Subject: FUEL DENSIFICATION

CHANGE NO. 21 TO THE TECHNICAL SPECIFICATIONS

LICENSE NO. DPR-19

SAFETY EVALUATION OF THE  
FUEL DENSIFICATION EFFECTS ON THE  
DRESDEN NUCLEAR POWER STATION UNIT 2

FIGURE 3.5.1 MAXIMUM ALLOWABLE PLANAR LHGR

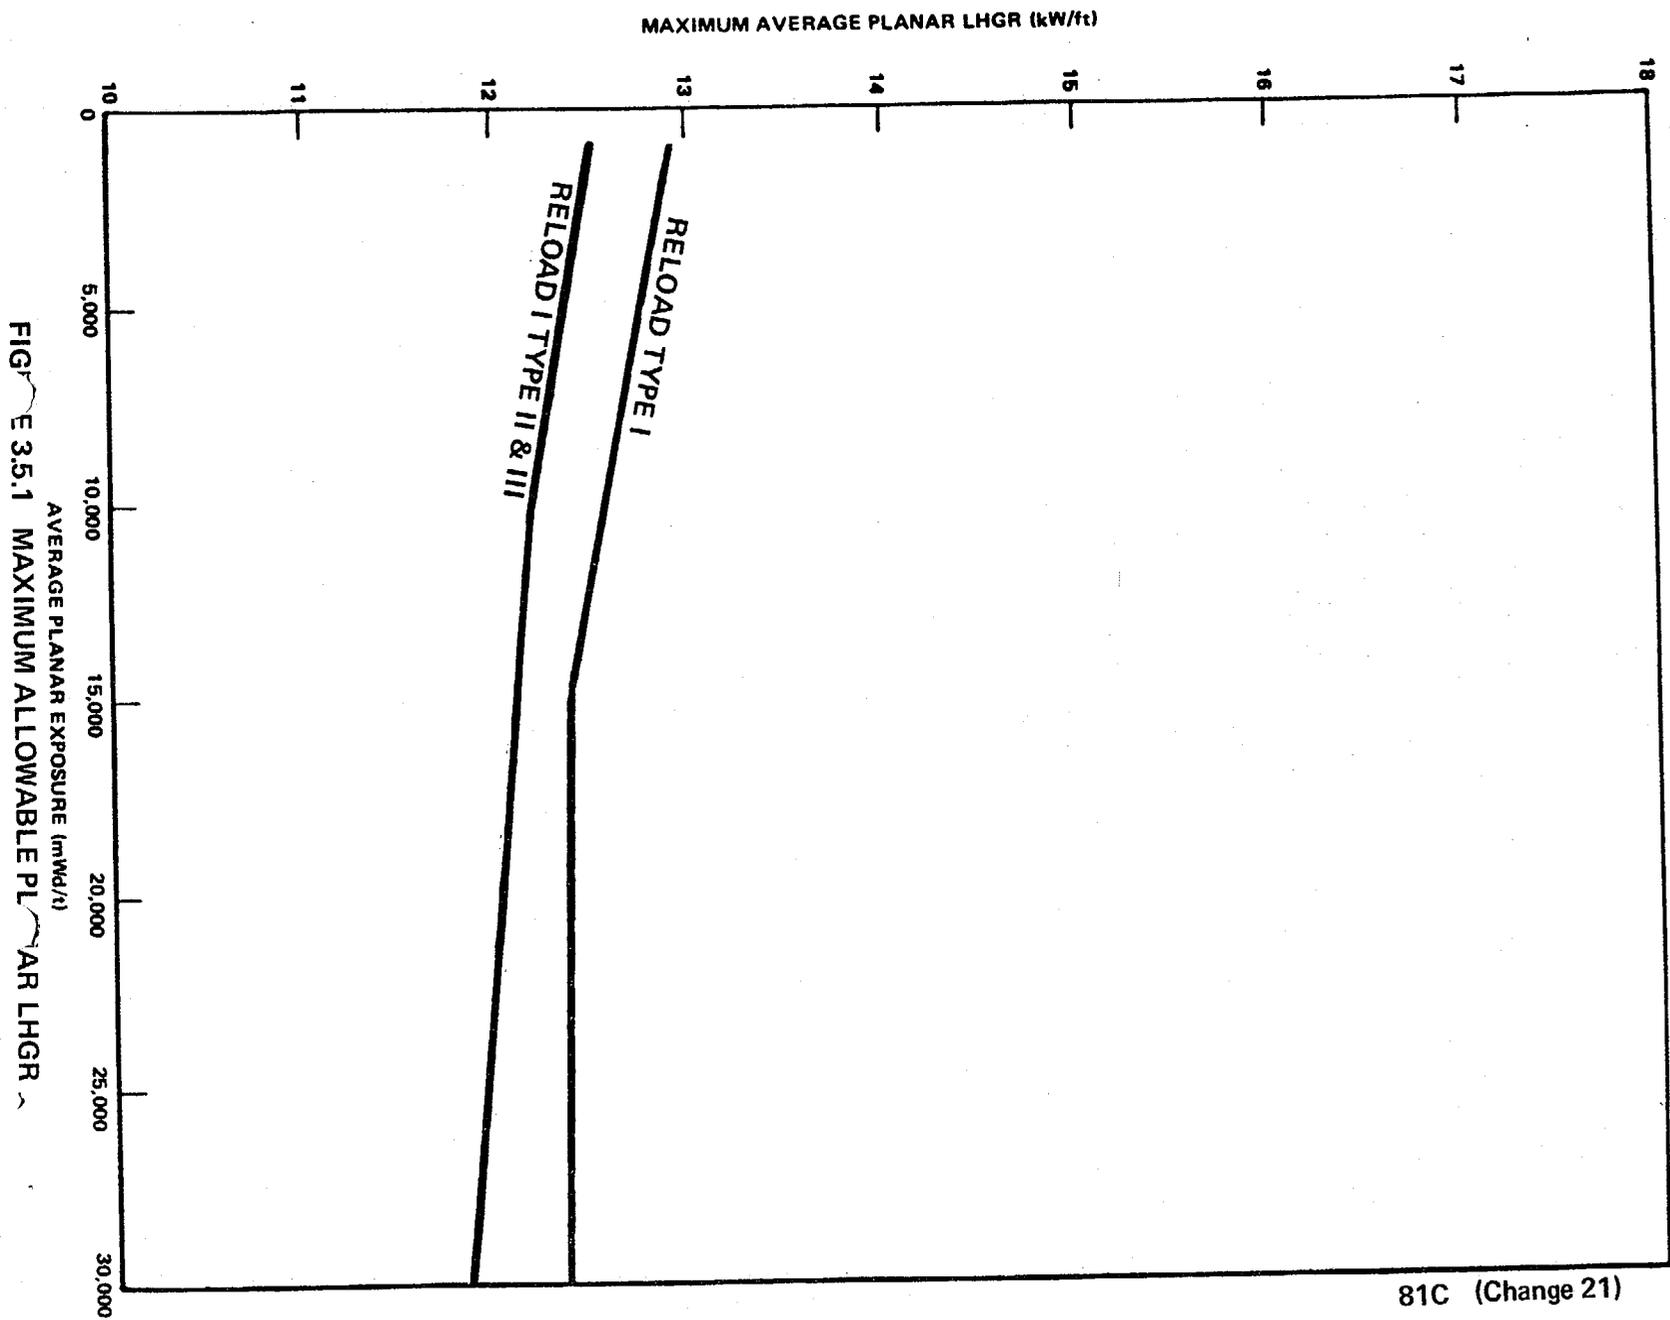
During steady state power operation, the average linear heat generation rate (LHGR) of all the rods in any fuel assembly, as a function of average planar exposure, at any axial location, shall not exceed the maximum average planar LHGR shown in Figure 3.5.1.

The maximum average planar LHGR shown in Figure 3.5.1 is the same as that shown on the curve labeled " $\gamma$ " (gamma) on Figures 4-9H1 and 4-9H2 of the GE topical report "Fuel Densification Effects on General Electric Boiling Water Reactor Fuel," NEDM-10735, Supplement 6, August 1973 and is the result of the calculations presented in Section 4.3.4 of the same report. These calculations were made to determine the effect of densification on peak clad temperature and were performed in accordance with the AEC Fuel Densification Model for BWR's which is attached to NEDM-10735, Supplement 6 as Appendix B.
